Application reference: WSCC/011/21

**Ford Circular Technology Park, Ford Road, Ford, Arundel BN18 0XL.
Demolition of existing buildings and structures and construction and
operation of an energy recovery facility and a waste sorting and transfer
facility for treatment of municipal, commercial and industrial wastes,
including ancillary buildings, structures, parking, hardstanding and
landscape works .**

**The Town and Country Planning (Environmental Impact Assessment)
Regulations 2017 - Regulation 25 Further Information and Evidence
Respecting Environmental Statements**

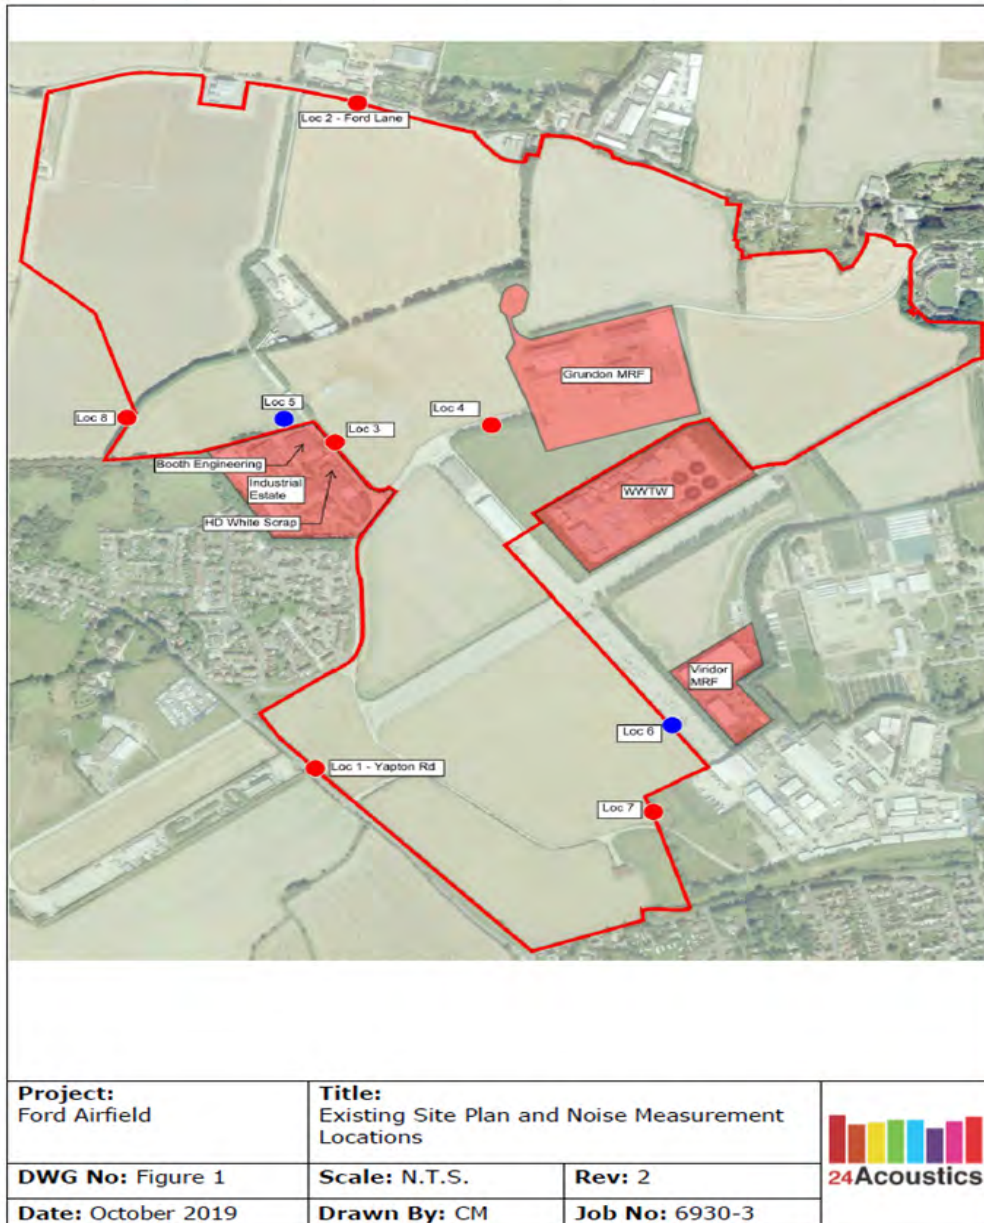
21. *Clarify what mitigation (including any physical features) has been assumed in the noise contours provided in ES Chapter 14, Figures 14.6 – 14.15 (i.e. both for construction and operational noise impacts).*

The construction noise contours allow for a 2.4m site hoarding (ES paragraph 14.75). The hoarding is shown in ES figures 14.6 - 14.12. Additional mitigation is expected to include Best Practicable Means, and so construction noise levels are expected to further reduce with these measures in place (see ES paragraphs 14.121 - 14.123).

The operational mitigation measures are detailed in ES paragraph 14.97.
